July 19, 2005  
9704-PFS-107

In accordance with the Reference correspondence and 10 CFR 21, Boeing is sending the NRC the attached error notices received from our former software suppliers. Because of unknown current addresses, the following former customers were not notified:

Enclosures: GT STRUDL Program Report Forms 2005.02 – 2005.04

# GTSTRUDL Program Report Form

GPRF No.: 2005.04

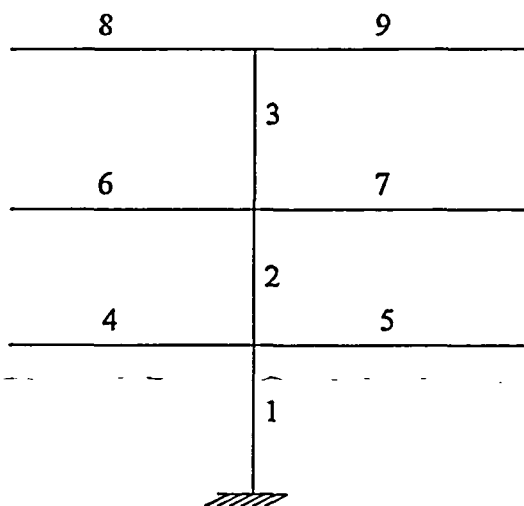
Automatic K-factor computations will be incorrect if the user specifies parameter FRLY or FRLZ for the beams or columns connected to the member for which the K-factor is being computed.

COLUMN LINE 'COL1' MEMBERS 1 TO 3

FRLY	0.5	MEMBERS 4 TO 9
COMP	KZ	MEMBERS 1 TO 3

COMP	YES	MEMBERS 1 TO 3
------	-----	----------------

CHECK MEMBERS 1 TO 3

Specify the parameters LY and LZ for the unbraced length. Do not use FRLY and FRLZ when requesting the automatic K-factor computation.
